DEVELOPMENT ASSESSMENT REPORT

Application No.	DA/2020/1103
Address	406 Young Street ANNANDALE NSW 2038
Proposal	Alterations and additions proposing a ground floor studio/garage structure with roof storage and associated works
Date of Lodgement	23 December 2020
Applicant	Anthony Cordato
Owner	Mr Anthony J Cordato
Number of Submissions	Initial: 12
Value of works	\$47,000.00
Reason for determination at Planning Panel	Number of submissions (12 Submissions) 10 Unique Submissions
Main Issues	Tree Removal; Solar Access
Recommendation	Approval with Conditions
Attachment A	Recommended conditions of consent
Attachment B	Plans of proposed development
Attachment C	Statement of Heritage Significance

Figure 1: Laneway Envelope

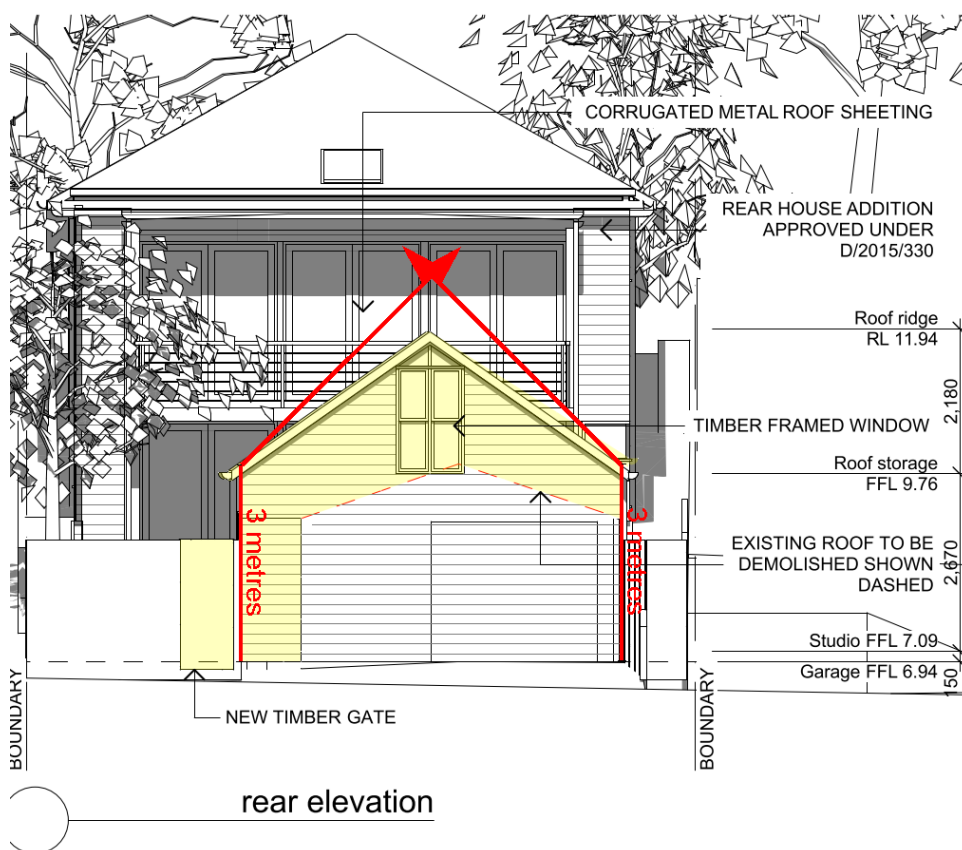
The following laneway envelope controls are applicable to the site:

Where fronting a Medium Lane, (refer to Table C11 Laneway hierarchy) development shall C6 comply with a laneway envelope that has:

- a. a maximum side wall height of 3.6m;
- b. a 45 degree building envelope taken from the top of the side wall; and
- c. a maximum roof height of 6m.

The below figure shows the applicable laneway envelope (red) plotted over the proposal.

The proposed structure is of a height, scale and envelope that is consistent with the applicable laneway envelope as demonstrated above. The structure is considered to comply with wider laneway objectives and controls as it respects the existing and desired future use, form and character of the laneway consistent with the laneway hierarchy, achieves an appropriate level of amenity, access, security and landscaping. The proposal includes minimal façade detailing and proposes a gable roof form consistent with Controls C4 and C13.

Given the above, the proposal is considered to comply with the suite of applicable objectives and controls having regard to Part 1.18 – Laneways.
